Accessibility Design Review Report - DA

Project Title: Caddens Corner Mixed Use/Residential Development
O'Connell St, Kingswood

Job Number: 22505

Report Version: 22505_ADR_DA_v1.2

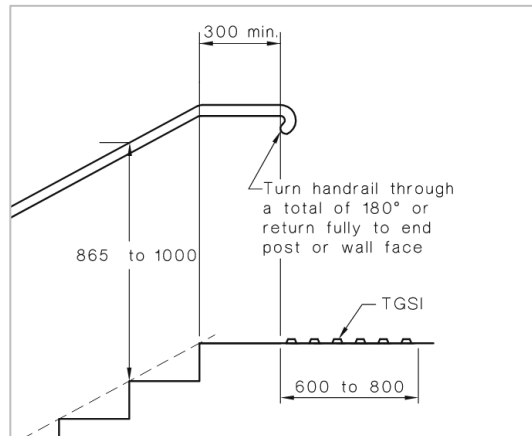
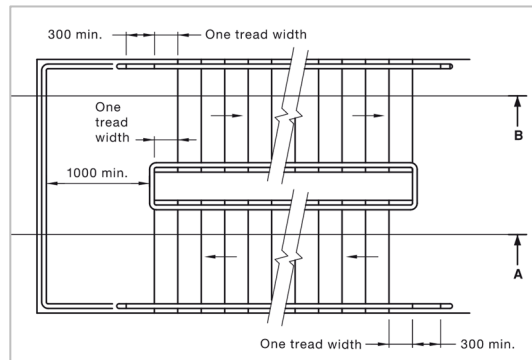
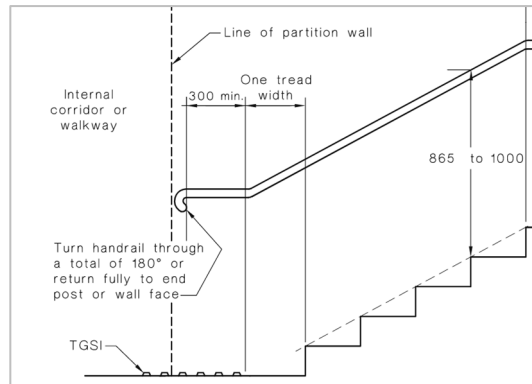
<p>Ensure all walkways (regardless of gradient) and ramps are provided with the associated accessible features such as handrails and TGSIs in accordance with AS1428.1 & AS1428.4.</p> <p><u>Design Detail:</u></p> <p>Ensure a level landing is provided at changes in direction, prescribed intervals and doorways along walkways and ramps in accordance with AS1428.1-2009.</p> <p>Many ramps to building entries through out are indicated with landings <1450mm.</p> <p>A small number of switch back ramps have landings <1540mm deep.</p> <p><u>Design Detail:</u></p> <p>Ensure one of the following forms of abutment from AS1428.1-2009 will be provided to either side of all walkways (1:20 or shallower).</p> <ul style="list-style-type: none"> • The floor or ground surface abutting the sides of the walkway shall provide a firm and level surface of a different material to that of the walkway at the same level of the walkway, follow the grade of the walkway and extend horizontally for a minimum of 600mm; • Kerb in accordance with Figure 18 (AS1428.1); • Kerb rail and handrail in accordance with Figure 19; or • A wall not less than 450 mm in height.

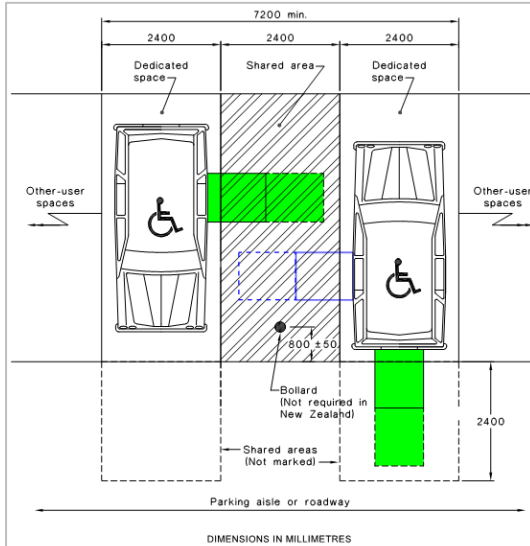
Ensure handrail extensions are provided at top and bottom landings of non-fire isolated stairways and setback/protected by a wall or similar in accordance with AS1428.1-2009 (examples below).

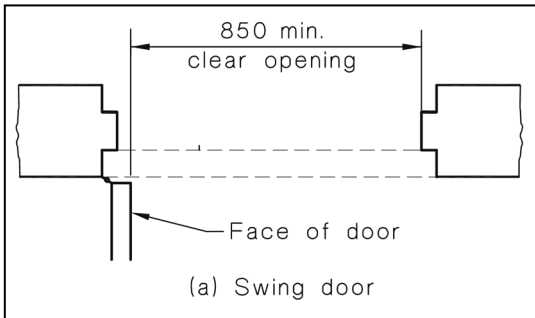
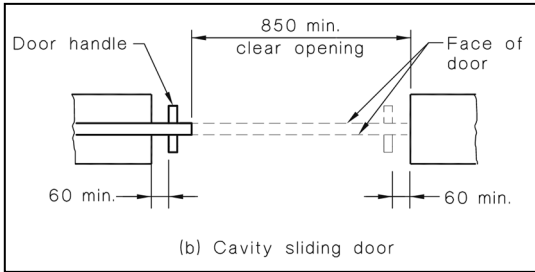
Requirement	Comments(s)
The development is proposed with a total of 469x Class 2 apartments.	57x (12%) apartments are nominated on plans to achieve the essential features of AS4299.
10% of apartments are required by Penrith Council to be designed with the essential features listed in AS4299.	49x associated adaptable parking spaces are proposed (designed to AS2890.1-2009).
Adaptable units are required to have an associated parking space.	123x apartments (26%) are nominated with Silver Level design features (57 adaptable apartments included).
The project team has also nominated to design apartments to the Silver Level of the Livable Housing Design Guideline.	An assessment of the adaptable & Livable housing units is provided in the following tables.
